APPLICATION REFERENCE: PF/24/2341

LOCATION: Home Farm Enterprise Zone, Hall Road, Cromer

PROPOSAL: Erection of 5 commercial units for uses within Use Classes E(c)(i) - financial services, E(g)(i) - offices, E(d) - indoor sport, recreation or fitness, B8 - storage or distribution

NORTH
NORFOLK
DISTRICT
COUNCIL

Access details

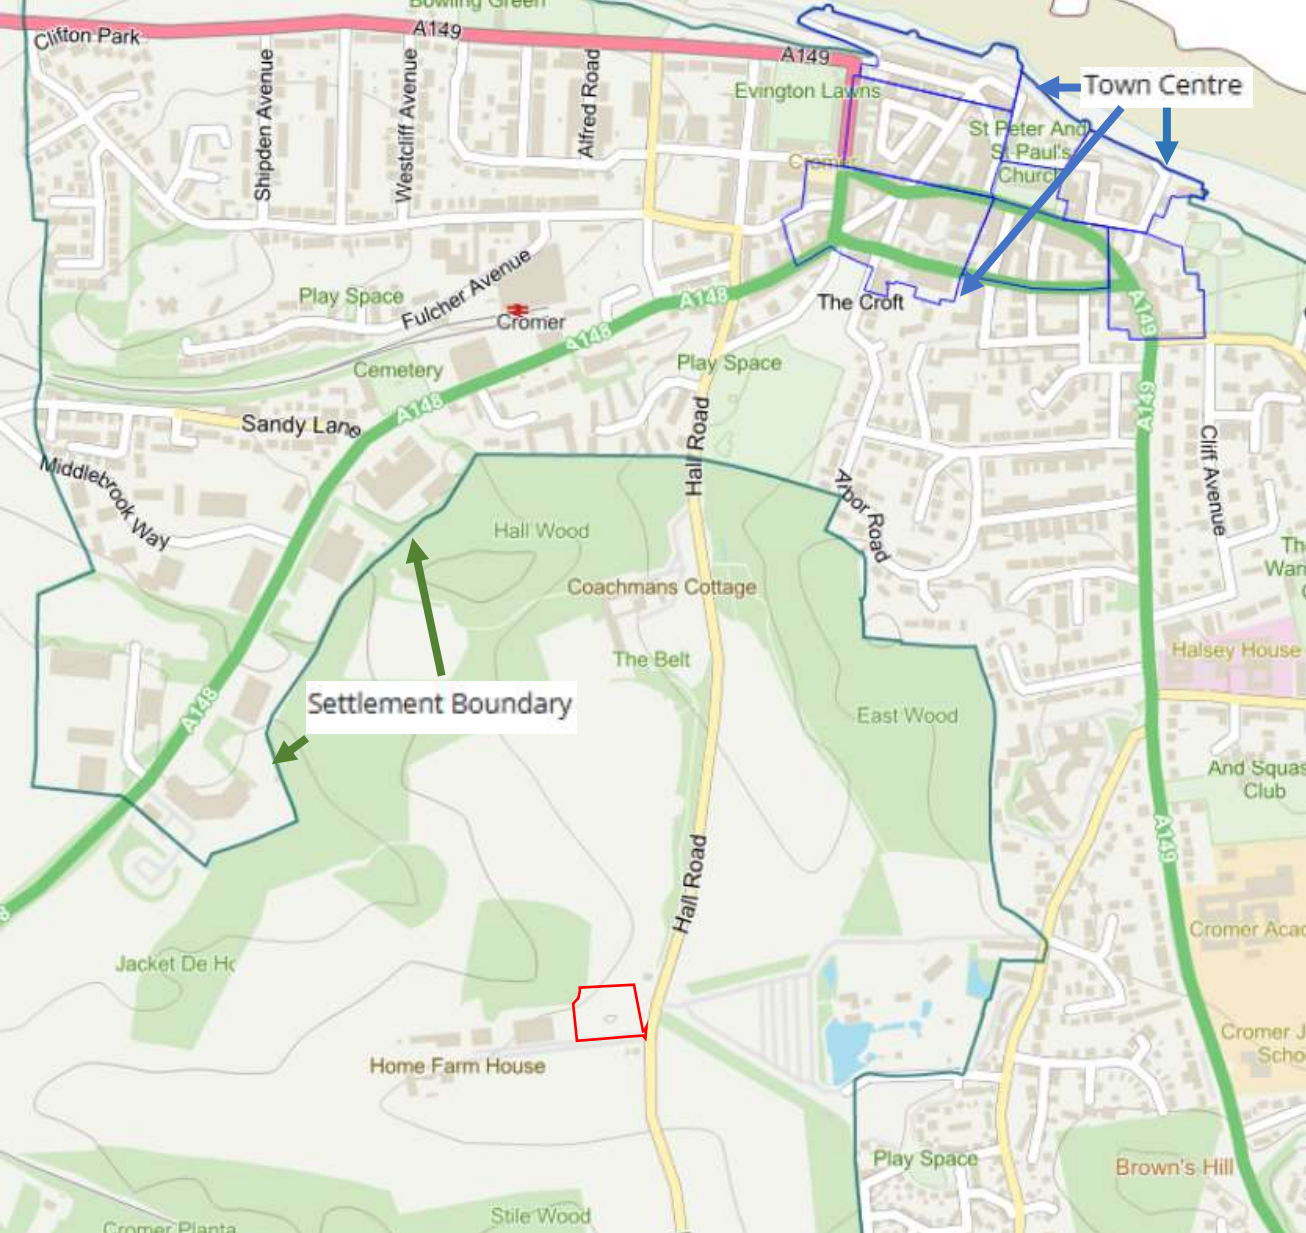
Extract from 24/06/25 highway comments – re. access

I understand there might be scope to provide improved visibility from the access. In the absence of a vehicle speed survey, I would suggest that 85%iles are likely to be in the region of 35mph at this location. Accordingly would suggest the visibility splays of 2.4m by 54m are sought in both directions.

The Highway Authority would generally limit radii at commercial accesses to 12m. The existing radii appear larger than would normally be supported but considering the reduced road width, they may help enable access by larger vehicles. The revised layout should be informed by vehicle swept-path analysis and the access radii constrained so far as possible.

The access layout is complicated slightly by the presence of the Home Farm Lodge access. I would highlight that the proposal seems to rely on using the adjacent access to accommodate waiting vehicles. I would suggest that to suitably accommodate two opposing vehicles at the access, it should be widened to 6.5m for a distance of 15m back from Hall Road.
